A. A. Takla Engineering, PLLC
 418 Vivaldi Dr.
 Durham, NC 27701
 NC Firm License # P-1446

Fuquay-Varina, NC
 Yasmin P-D
 Lot #2
 c/o Ricky Omar

SD1

0 JASMIN RD - LOT2 BLOCK 12
FUQUAY VARINA NC, 27526

Crawl space ventilation FOUNDATION PLAN 1
SCALE: 1/4" = 1'-0"

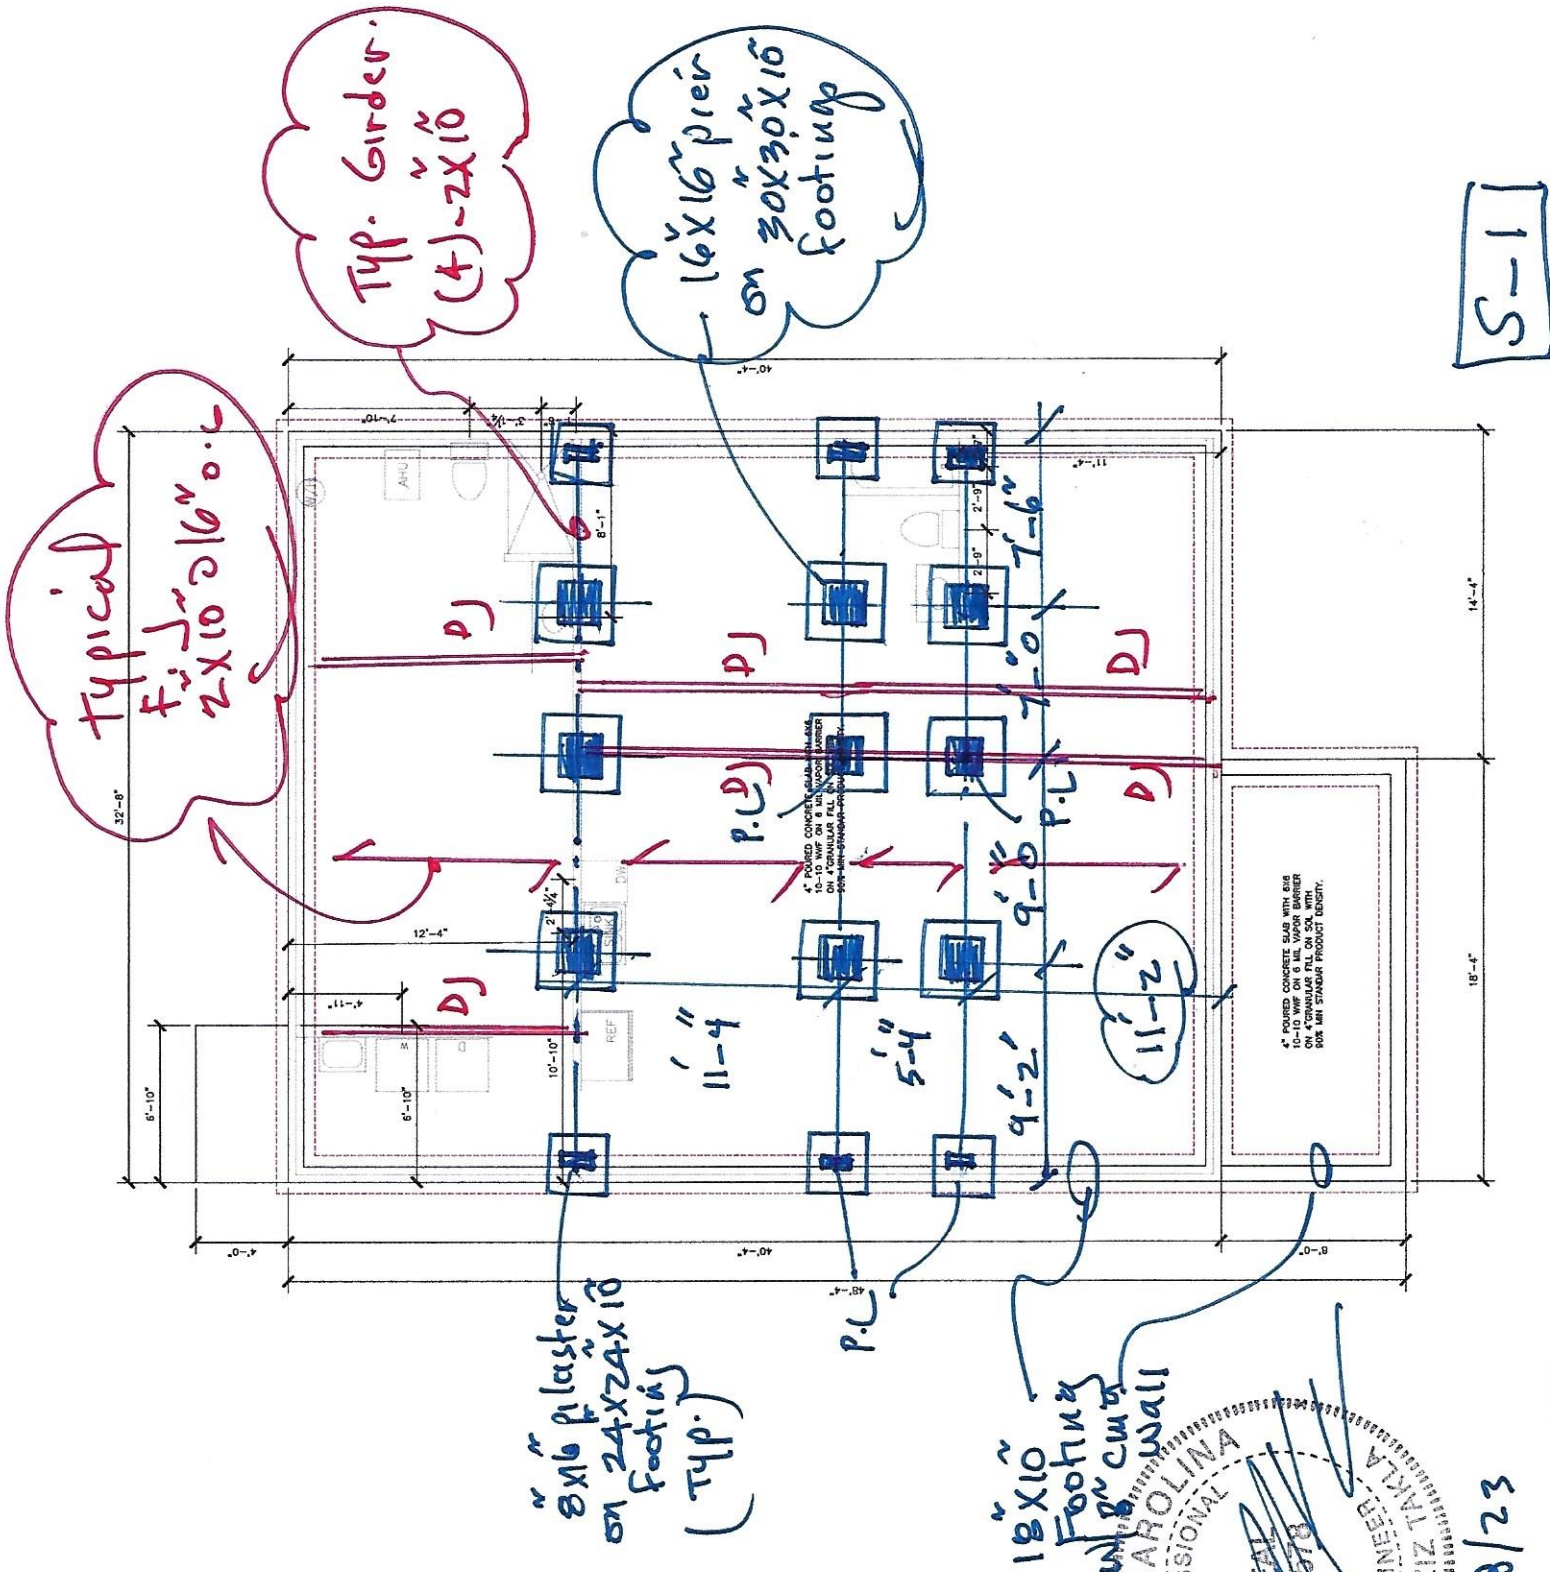
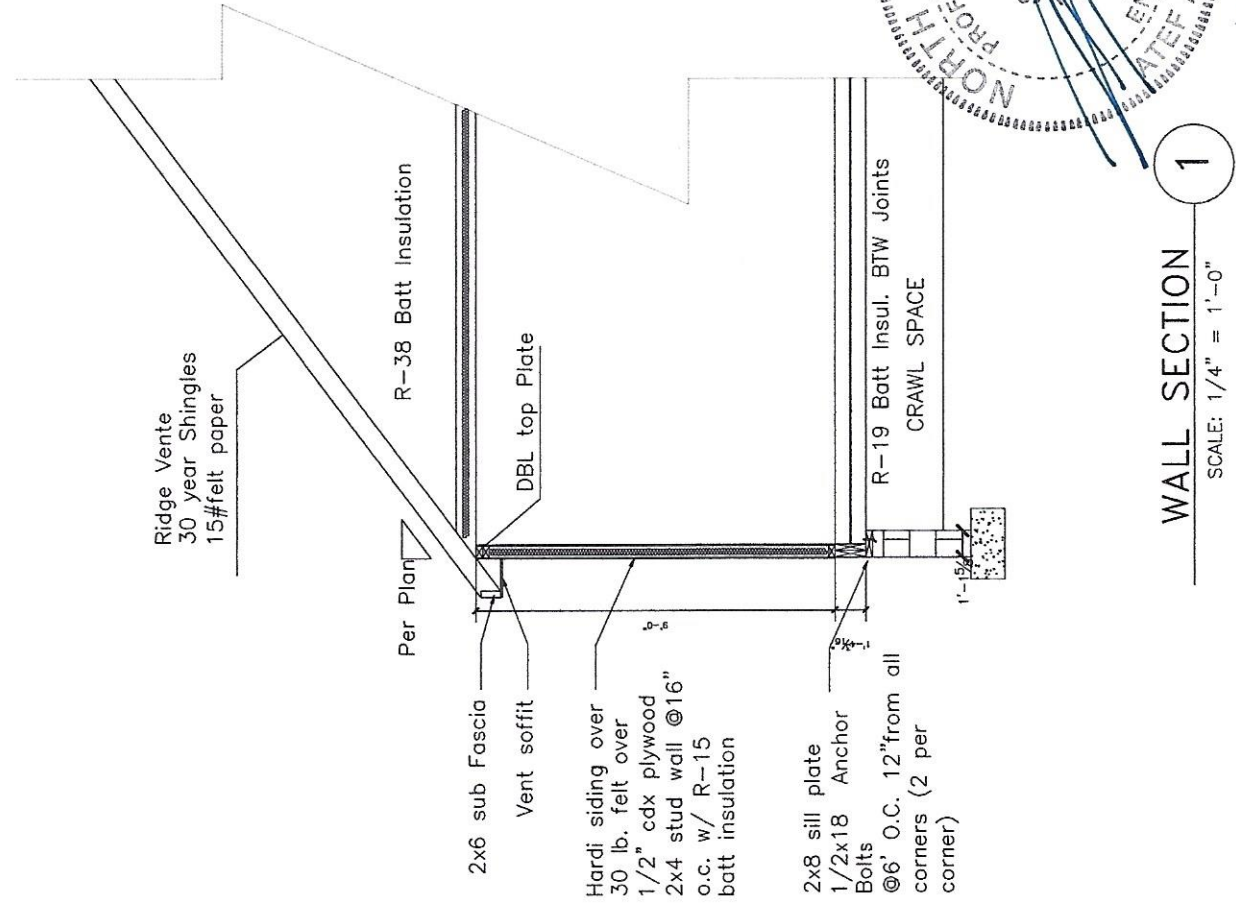
18x10 Footing in concrete wall
AA TAKLA ENGINEERING, PLLC
NC FIRM LICENSE NO. P-1446
ENG'S SEAL FOR STRUCTURAL OR
919-358-1758

FLOOR PLAN 1
SCALE: 1/4" = 1'-0"

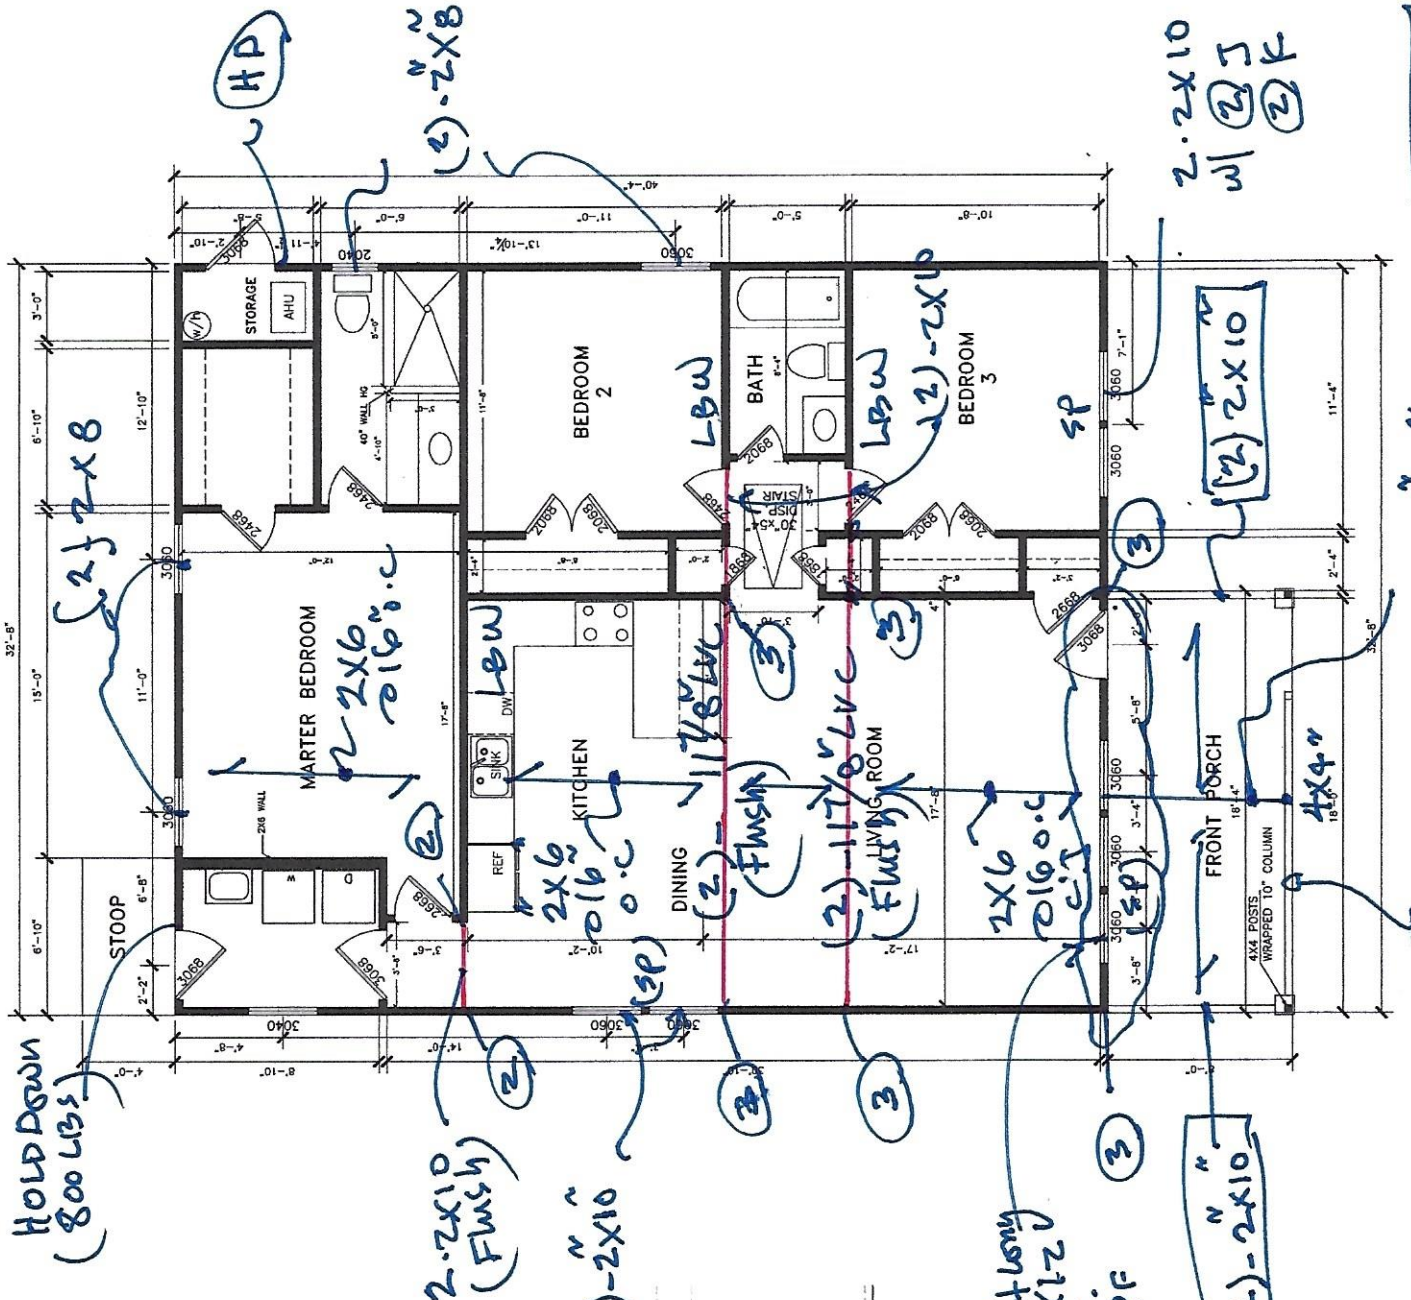
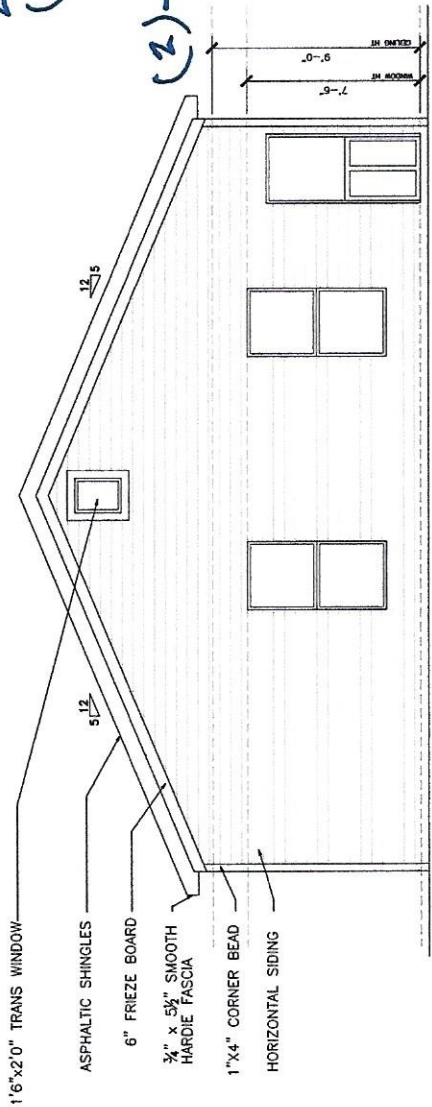
Hold Down
(800 lbs)

2x10
(Flush)

(2)-2x10

19' ft long
(2)-2x12
cont.
CS-PF

(2)-2x10

2x2x10
w/ 2x5
2x6

(2)-9/4 LVL
